Re: **Application by – Perkins & Company Architecture and Urban Design Inc. at
4311 Bayview Street**

**Report to
Development Permit Panel**

To: Development Permit Panel
From: Joe Erceg
Manager, Development Applications
Re: **Application by Perkins & Company Architecture and Urban Design Inc. for a
Development Permit at
4311 Bayview Street**

IMPERIAL LANDING AT STEVESTON - Parcel F4

SITE PLAN 1/16"=1'-0"

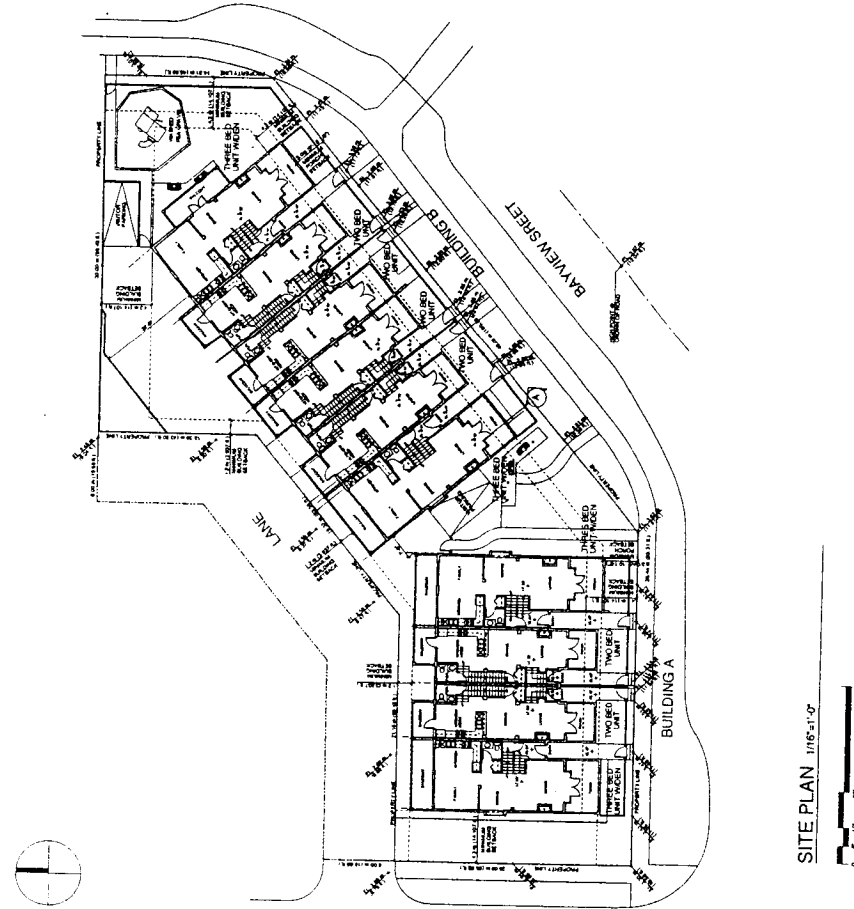
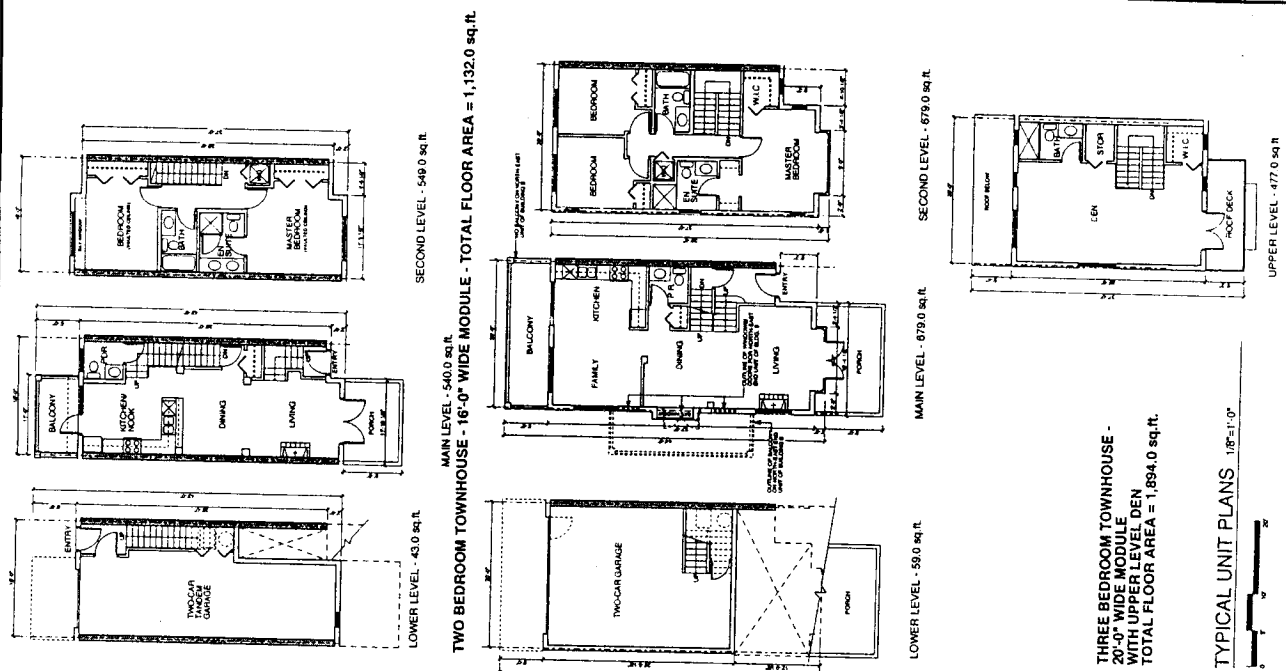
1. Consider a split-level main floor plan for the units at the end of each townhouse block to ease the transition between the finished floor elevation of the main floor and the boulevard sidewalk elevation. *A transition between the finished floor elevation of the main floor and the boulevard sidewalk elevation has been achieved through gradual elevation changes as you walk up the landscaped stair/gate entry, through the entry porch, through the front door, and up a few risers to the main living space (refer to F4 site plan sheet for finish grade information).*

6. Eliminate the requested variances along Bayview Street by reducing the depth of the entry porches and stairs, thereby making the front yards more functional. *Entry porch and stair depth variance is still requested. We feel that a deeper porch facing Phoenix Pond provides a more usable and flexible semi-private space. Based on the Design Panel's feedback, larger porches are encouraged. However, the access walkways for the 16 foot wide units have been realigned between the sidewalk and front entry there by creating a more direct approach to the front entry and providing more front yard space as desired by the Planning Department (refer to F4 site plan sheet).*

1. Indicate with spot elevations, the grade transition from the sidewalk on the boulevard to the finished floor elevation of the townhouse main level(s). *Spot elevations showing the grade transition from the sidewalk to the main townhouse level have been added to the plan (refer to F4 site plan sheet).*

2. Relocate the visitor-parking stall along the lane to a location between the two blocks of townhouses. Eliminate the corner support column for the balcony at the north-east corner of the western block of townhouses or cut back the width of the balcony in this location. Provide appropriate separation and landscape screening for the relocated visitor-parking stall from the street. Increase the amount of planting area adjacent to the lane. *The visitor parking space at the south-west portion of the site has been moved closer to the building to allow for more landscaping between the site and the right-of-way (R.O.W.) "visitor" parking space at the north portion of the site has been relocated to the north-east portion of the site adjacent to the townhouse end unit. Locating a visitor parking space between the two townhouses is not achievable because the space will block garage access to the north unit in Building A (refer to F4 site plan sheet).*

3. Eliminate the fencing and hedging that separates the three landscape side yards from the street boulevard. Create semi-public spaces in these locations along the street and propose a landscape treatment that is more transparent and visually accessible from the sidewalk. Consider foundation planting rather than perimeter planting. For the eastern two locations, reconfigure the pedestrian circulation in these side yard locations to provide a loop path from the public sidewalk including seating and trellis structures plus the children's play area in the north-east corner of the site. In the western side yard provide benches along the sidewalk. *Fencing has been removed to the side yards and the landscaping amended. Benches have been added to two (2) of the side yards to create semi-public spaces. Fencing around the north-east corner suite has been retained to provide security for the children's play area.*

2. As requested, the applicant has provided two visitor parking stalls in the site plan for this development (2.65 m x 5.5 m). However, the orientation and/or location of the north visitor stall may block the garage entrances for some of the units. The applicant should demonstrate that vehicles would be able to access and egress from the two northern units with the proposed visitor stall. Alternatively, consider relocating the north visitor-parking stall. ***Vehicles will be able to access and egress from the two (2) northern units. A manoeuvring aisle of 28 ft. 8 in. has been provided (refer to F4 site plan sheet).***
